Note !

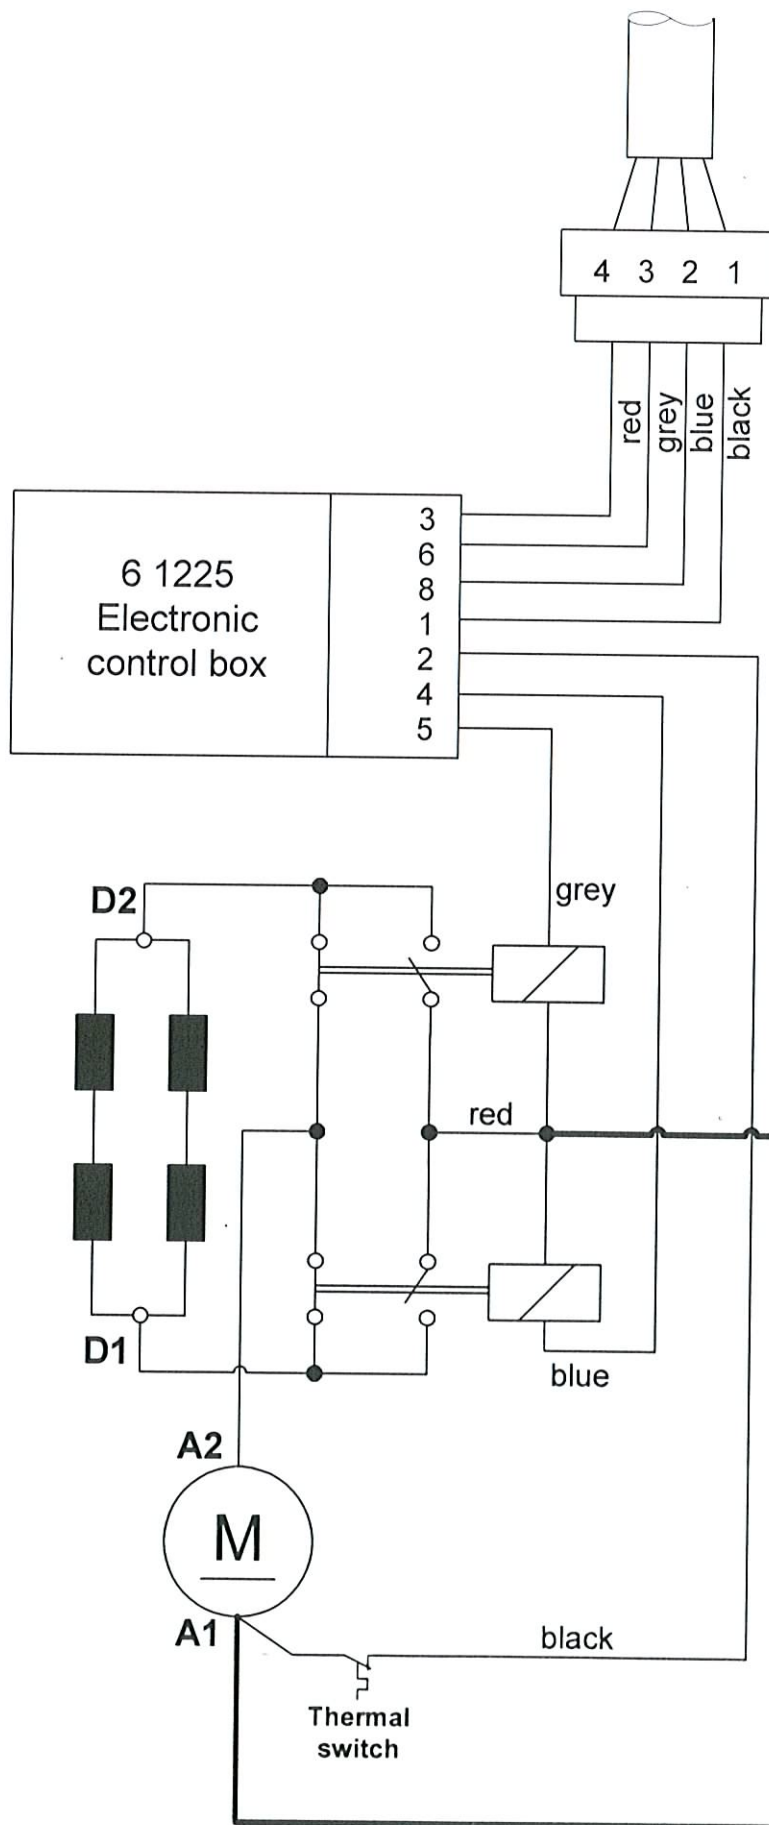
On models with electronic controlbox type 6 1224 pin1 and pin2 was connected in one as pin2

The new 6 1225 electronic controlbox can replace the 6 1224 box and have the same function, while you can not connect the 6 1224 box to a wiring loom made for the 6 1225 box.
